Access Compliance Report

Public Rights-of-Way

(Curb Ramps)

Intersection ID: 30470	Main Street: OWLS_PERCH_DR	Cross Street: PLANTERS_ROW_DR	Location: SW
ADA ID: AB8367D615DF	Ramp Type: Directional1	Initial Pass/Fail: Fail	Overall Compliance: No
Severity Score: 1.25			
Codes/Mitigation Info/Possible Solution		Field Measurements/Component Compliance

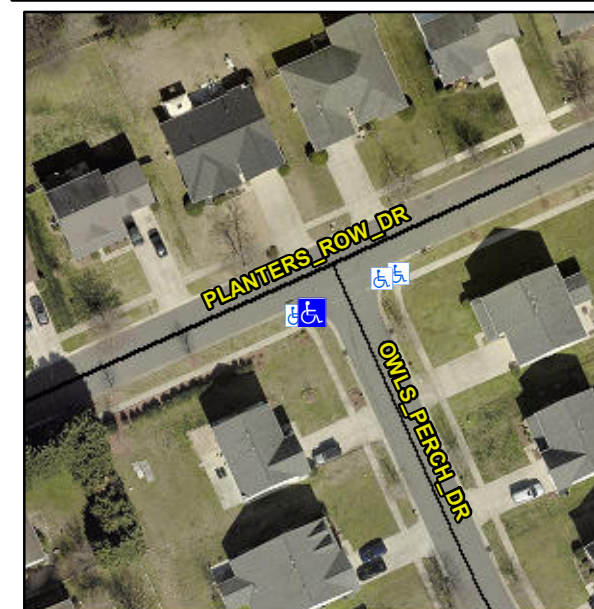
R304.5.3

Compliance	Description	Data	Compliance	Description	Data
N/A	Ramp Length (in)	21.0	N/A	Grade Break?	N/A
Yes	Ramp Width (in)	62.0	N/A	Grade Break Slope (%)	0.0
Yes	Ramp Slope (%)	0.2	N/A	Grade Break XSlope (%)	0.0
No	Ramp XSlope (%)	4.0			
N/A	Flare Type LT	N/A	N/A	Flare Type RT	N/A
N/A	Flare Slope LT (%)	N/A	N/A	Flare Slope RT (%)	0.0
N/A	Flare Traversable LT?	N/A	N/A	Flare Traversable RT?	N/A
N/A	Landing Length (in)	0.0	N/A	DWS Provided?	N/A
N/A	Landing Width (in)	0.0	N/A	DWS Contrast?	N/A
N/A	Landing Slope (%)	0.0	N/A	DWS Length (in)	N/A
N/A	Landing X Slope (%)	0.0	N/A	DWS Full Width?	N/A
N/A	Landing Curb? (Y/N)	N/A	N/A	DWS Offset LT (in)	N/A
N/A	Shared Landing?	N/A	N/A	DWS Offset RT (in)	N/A
N/A	Gutter Ponding?	0.0	N/A	Gutter Slope (%)	N/A
N/A	Gutter Lip Ht (in)	0.0	N/A	Gutter X Slope (%)	N/A
N/A	Painted X Walk1?	No		Road Slope (%)	2.7
	X Walk 1 Direction	To NE		Road X Slope (%)	0.3
	X Walk 1 Width (in)	N/A		Clear Space?	N/A

Remove & Replace Entire Ramp.
